Babylon Garments & Dresses Ltd. (Extension)

24 December 2023

2. Observations

Observation-1: Lack of lateral stability for roof (Store Building).

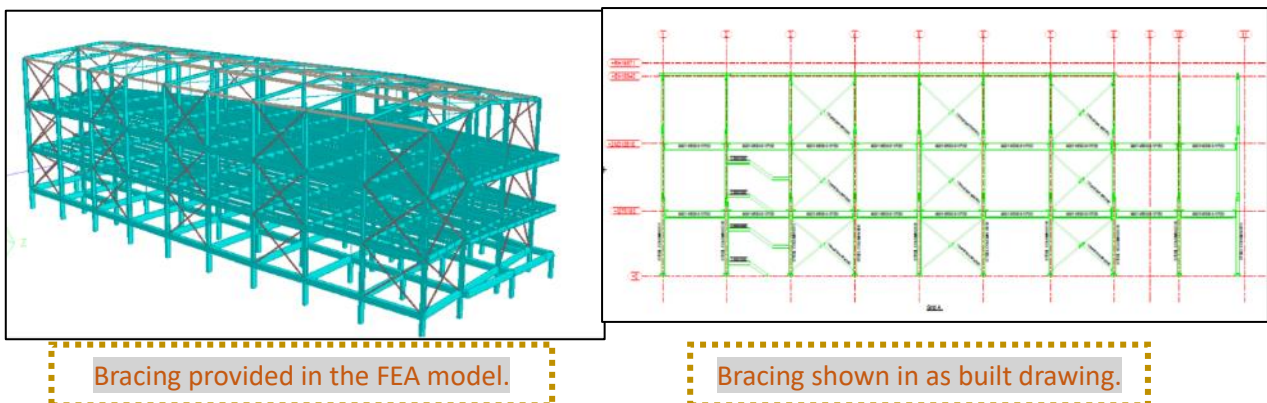
Description: Compression strut is provided at east side only and lateral stability system appears to be incomplete. The building engineer is required to check the lateral stability of the structure and propose remedial measures if required.
